Lyle Falls Fish Passage Project

Final Environmental Impact Statement

DOE/EIS-0397

**Lyle Falls Fish Passage Project Final Environmental Impact Statement (EIS)
DOE/EIS-0397**

Figure 3-8. Land Ownership.

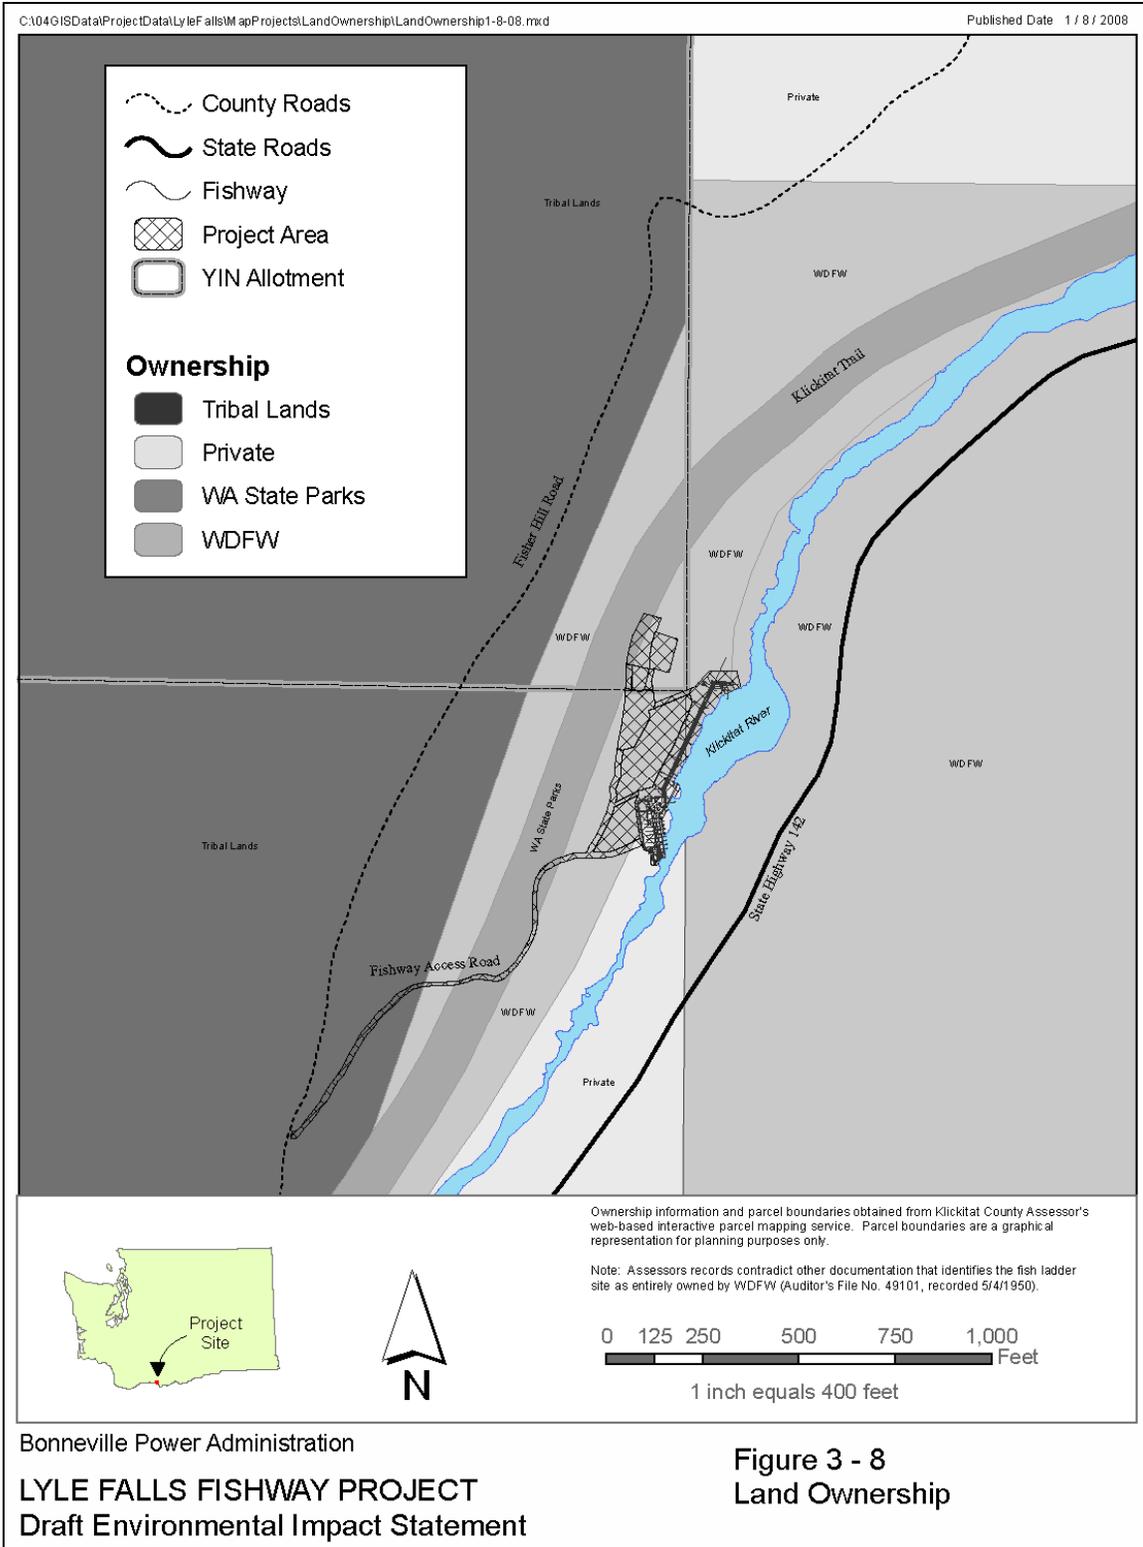
Figure 3-8 on **page 3-101** of the DEIS has been modified, extending the mapped coverage of the Klickitat River. It is included at the conclusion of this section (page 24).
